**NORTH SYDNEY LOCAL PLANNING PANEL****DETERMINATIONS OF THE NORTH SYDNEY LOCAL PLANNING PANEL  
MEETING HELD IN THE COUNCIL CHAMBERS, NORTH SYDNEY,  
ON WEDNESDAY 4 JUNE 2025, AT 2.00PM.****PRESENT IN SUPPER ROOM****Chair:**

<b>DA No:</b>	DA 275/24
<b>ADDRESS:</b>	20 Bay View Street, Lavender Bay
<b>PROPOSAL:</b>	Demolition of an existing dwelling and construction of a new dwelling
<b>REPORT BY NAME:</b>	Rachel Wu, Assessment Officer
<b>APPLICANT:</b>	Ming Hao Wu

Figure 1: Delete portion of WIR and bathroom. Area to be deleted shaded red.

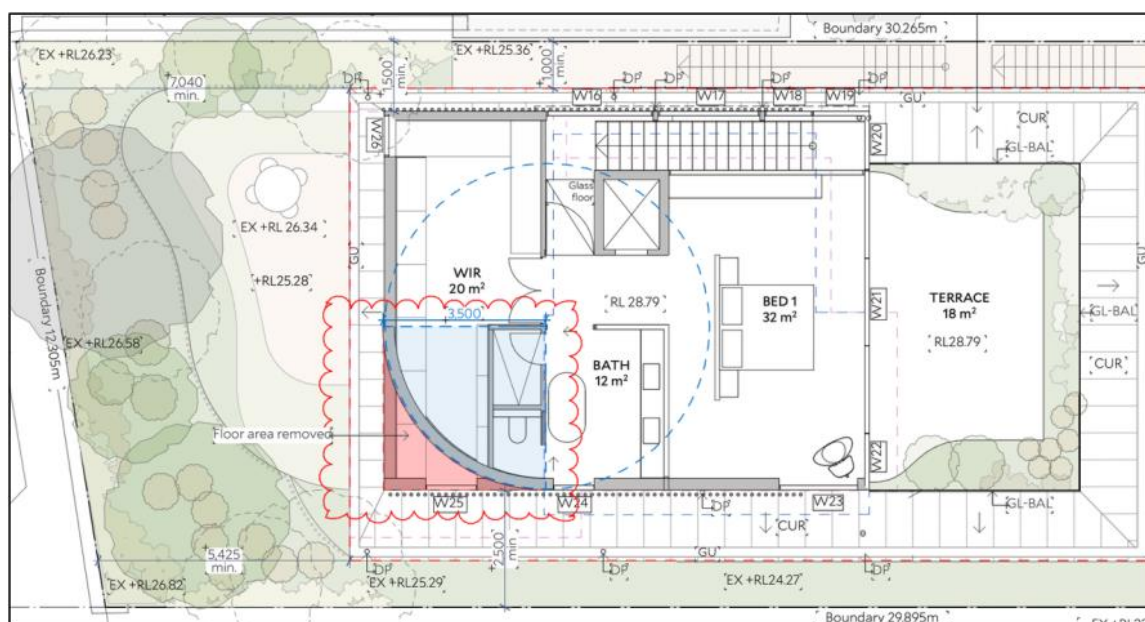
A5. The red area in Figure 1 must be deleted and should not be reconfigured or converted into internal GFA due to the view corridor. The roof plan should be updated to reflect the new envelope.

(Reason: To ensure the composition of iconic view of the Sydney Harbour Bridge is protected for 19 King George Street; To ensure view sharing in accordance with *NSLEP 2013* and *NSDCP 2013*)
